**MAJOR PROJECT ASSESSMENT:  
Mixed-Use Residential, Motel & Retail Development  
Lots 1 and 2, Section E, DP 17053  
85-87 Ocean Parade, Coffs Harbour  
Proposed by Kann Finch Group Pty Ltd**

Director-General's  
Environmental Assessment Report  
Section 75I of the  
*Environmental Planning and Assessment Act 1979*

February 2007

**Figure 5** Shadow Diagram, 6.30pm December 22<sup>nd</sup>  
(Blue shading is the overshadowing on the cleared (grassed) dune area).

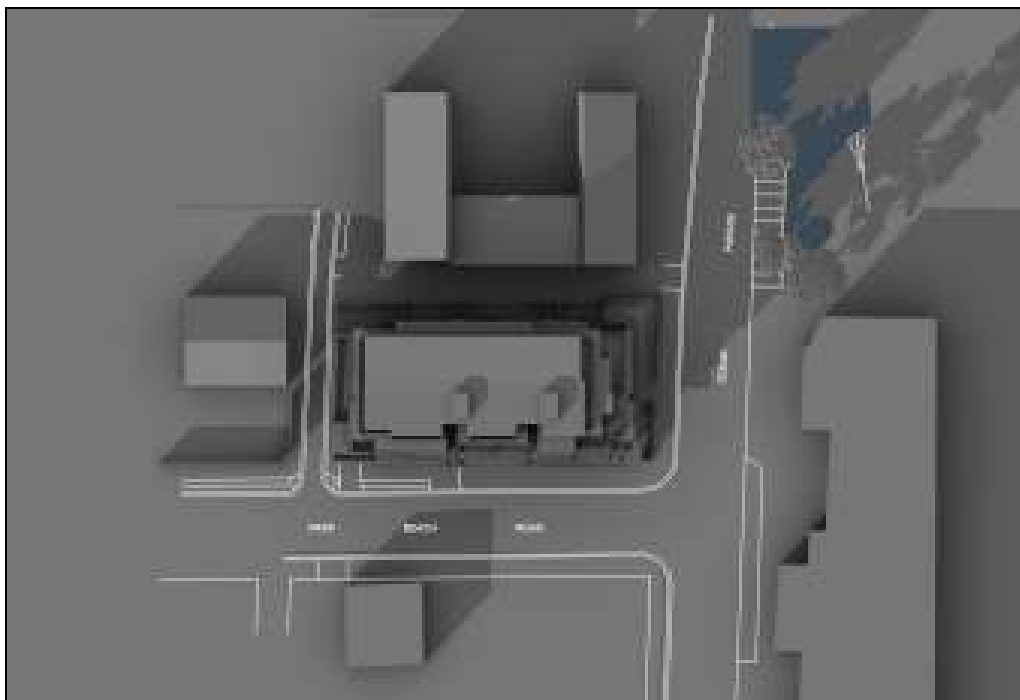
The Proponent claims that the proposed development complies with the intent of this clause to the extent that no overshadowing occurs for the midwinter period before 3pm and that only minor additional overshadowing occurs before 6.30pm daylight saving time midsummer to the extent that the overshadowing occurs on cleared land. The Proponent also argues that natural coastal dune vegetation is not overshadowed, rather cleared open space, and therefore the extent of non-compliance is considered to be of an extremely minor nature and will have no detrimental effects of the preservation of the coastal dune area, or the amenity of the small section of the coastal strip.

As the overshadowing will not extend beyond the dune onto the beach, it is unlikely any sunbathers or users of the beach will be affected. Accordingly, the Department has considered that in the context of the surrounding developments, the current height controls for the site, and the stepped back design of the proposed development, this minor overshadowing is considered. An assessment of the proposal against the NCREP is at **Appendix D (Tag D)**. **Figure 5** below shows the extent of overshadowing on the dune area.
